ADDENDUM NO. 3

RE: **Athletic Performance Addition**
Perkinston Campus, MGCCC
Perkinston, Mississippi
A/E Project No. 26-028a

FROM: EGH Architects
1091 Tommy Munro Drive
Biloxi, MS 39532
(228) 594-2323

M001

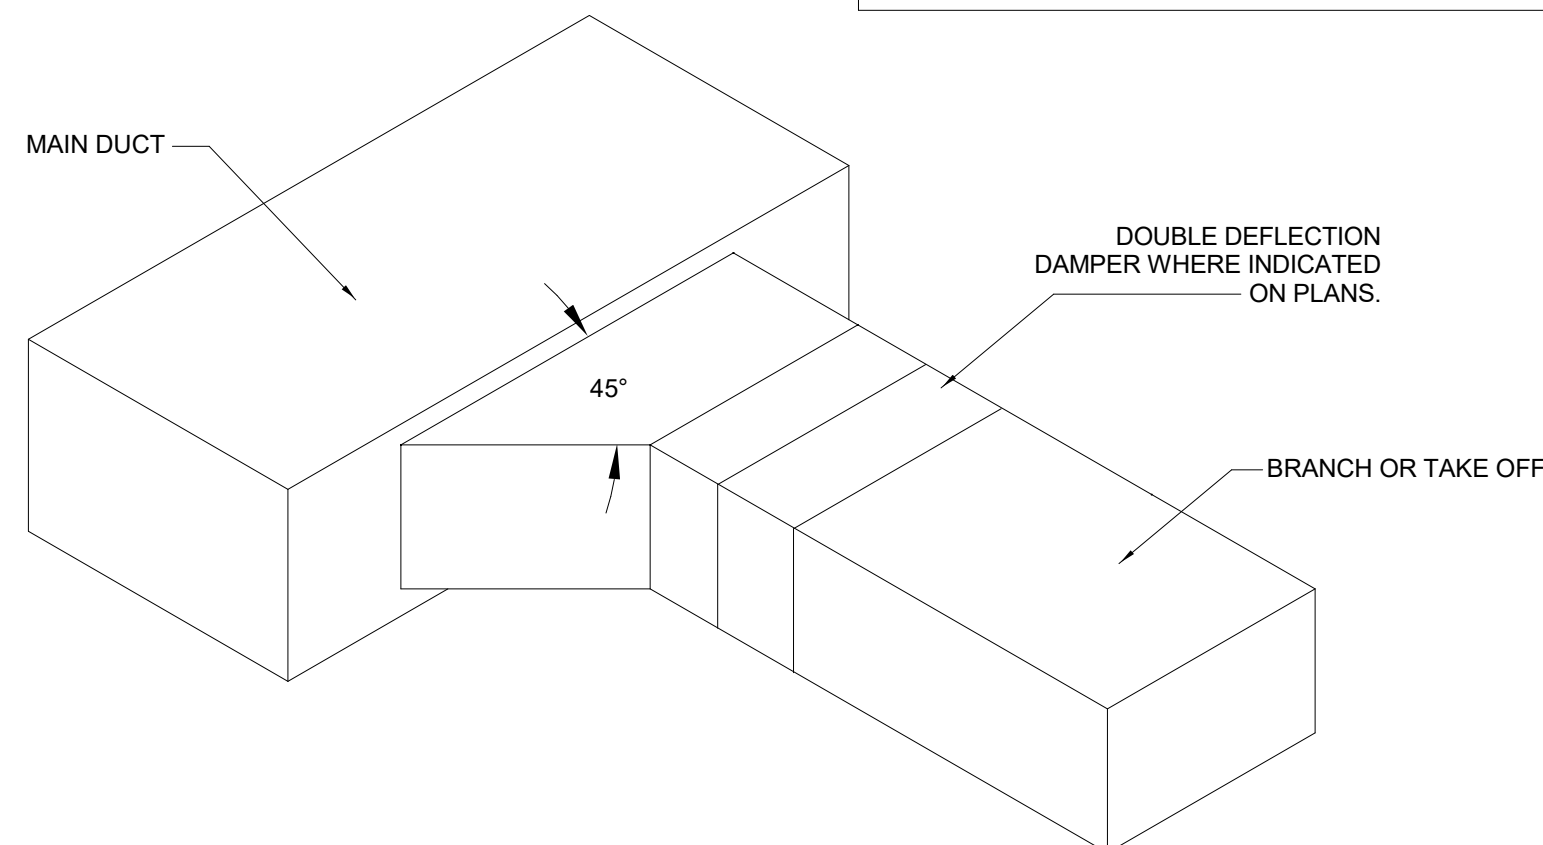
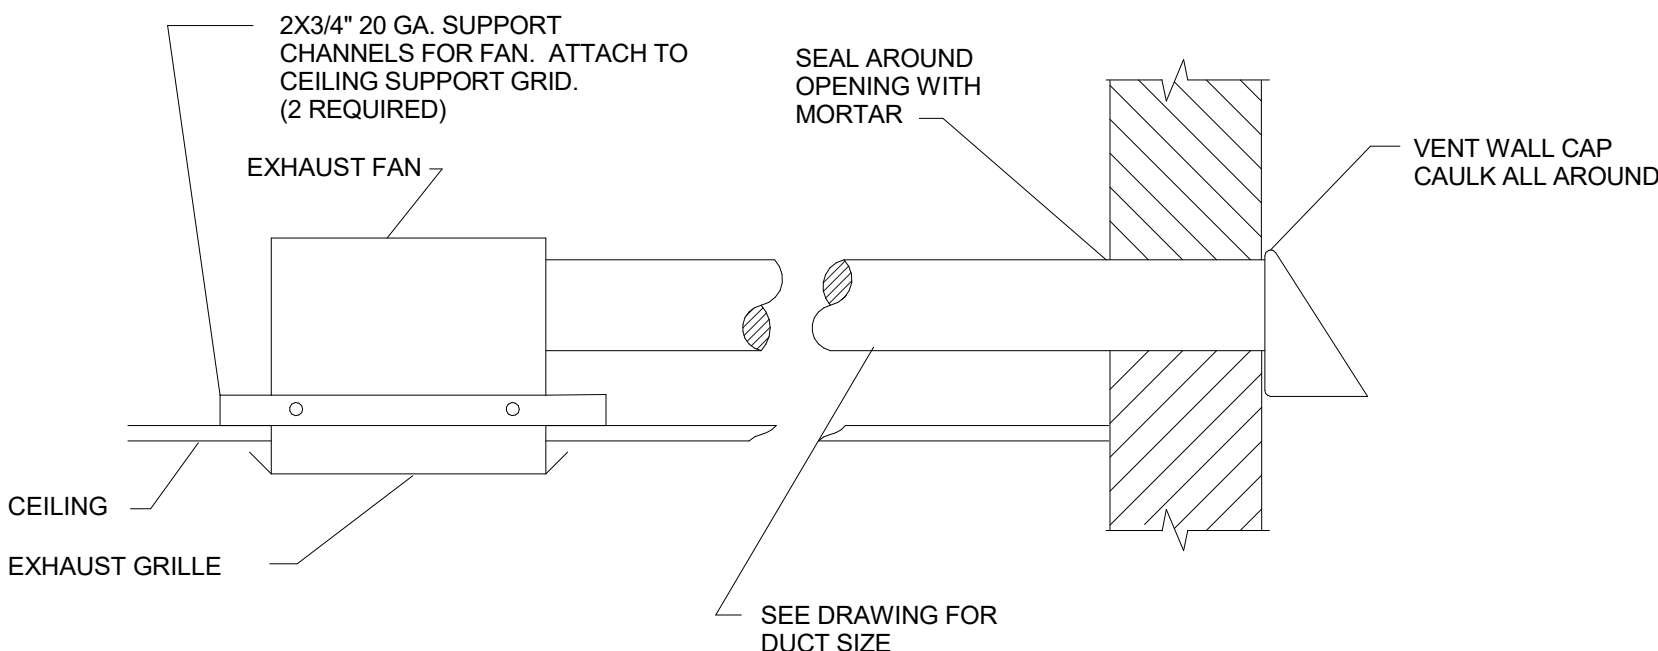
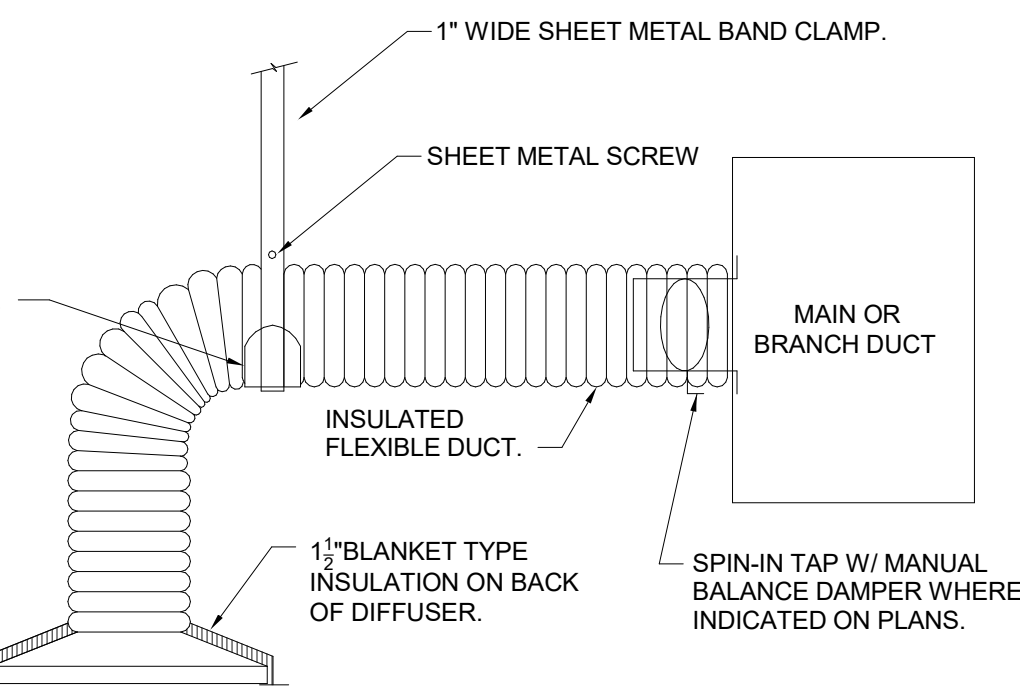
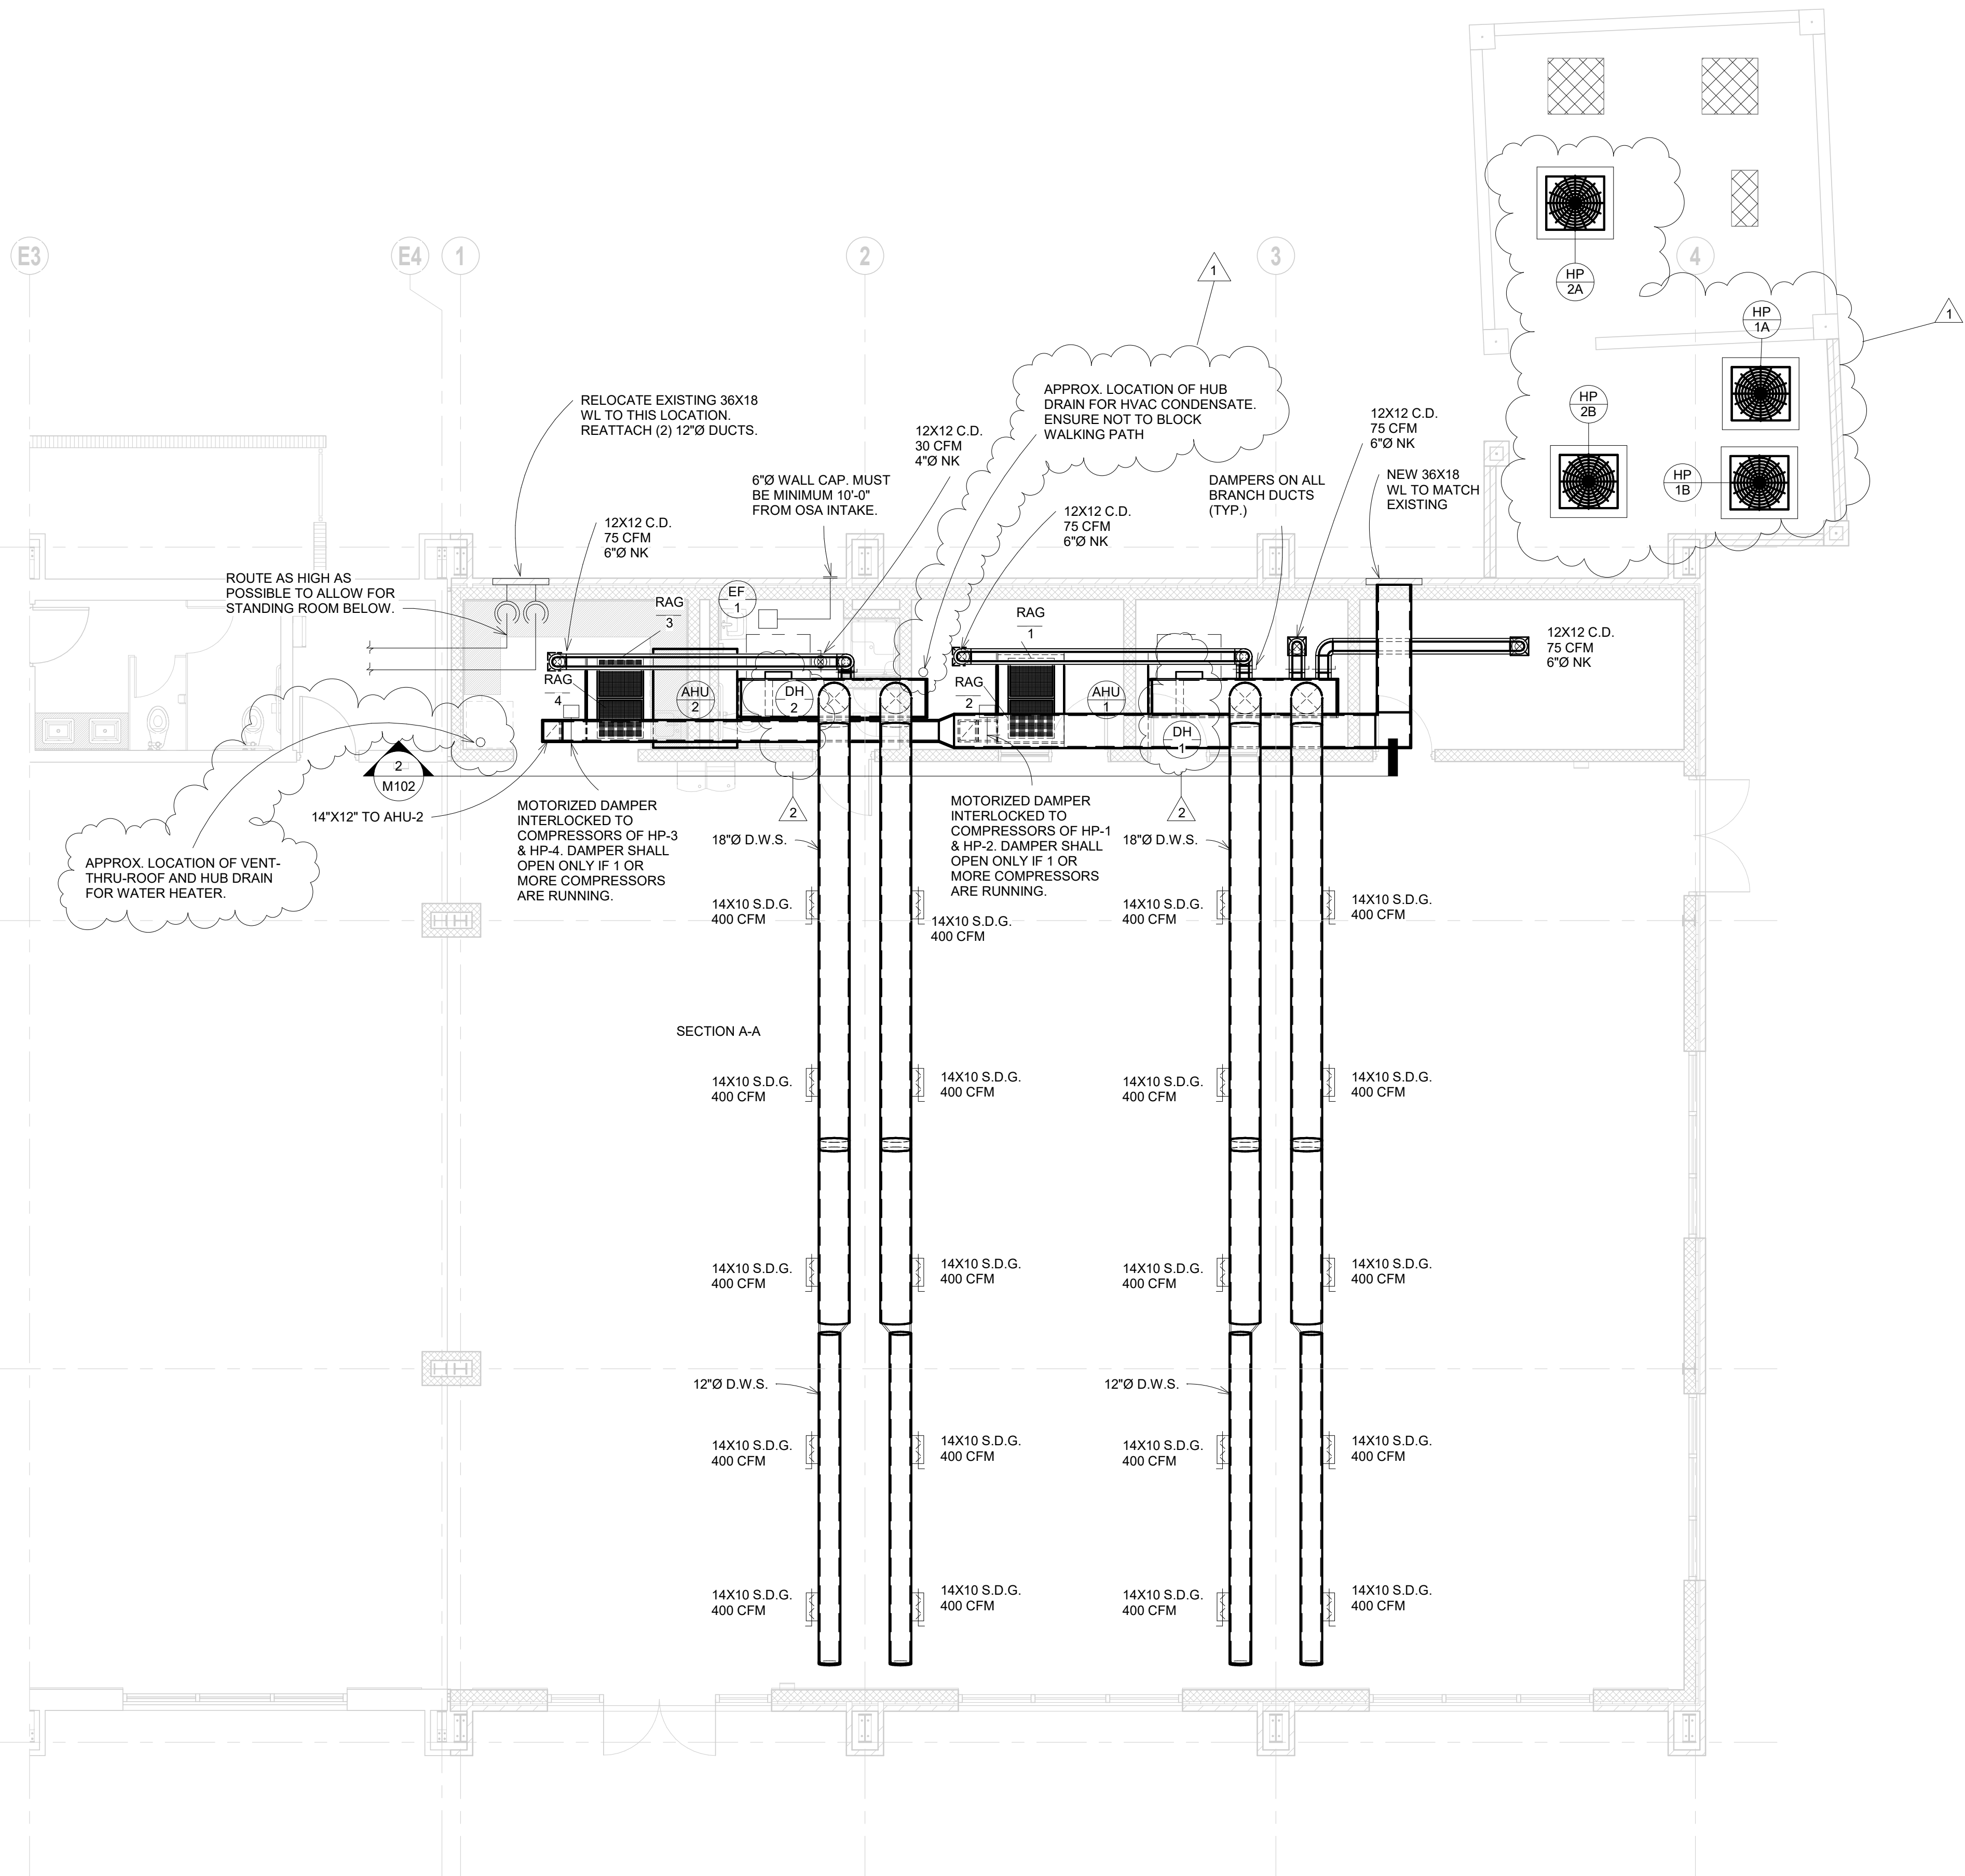
Q10. There are two Duct Heaters (one at each unit) shown in the drawings, but no schedule for them. What KW and voltage should be used?

- Added schedule for the electric duct heaters.
- Removed electric auxiliary heat from HEAT PUMP SPLIT SYSTEM SCHEDULE. This changed the electrical requirements of the air handler. The auxiliary heat is handled by the duct heaters.

R10. See revised sheet M001 attached.

MARK	KW	VOLTS	φ	HEATER STAGES	WIDTH X HEIGHT	MODEL
DH- 1,2	30	240	1	3	24 X 16	GREENHECK IDHB-30KW
ACCESSORIES: BUILT IN T-STAT, BUILT IN CIRCUIT BREAKER, DISCONNECT, MOUNTING HARDWARE

- The numbering for the electric duct heaters corrected.
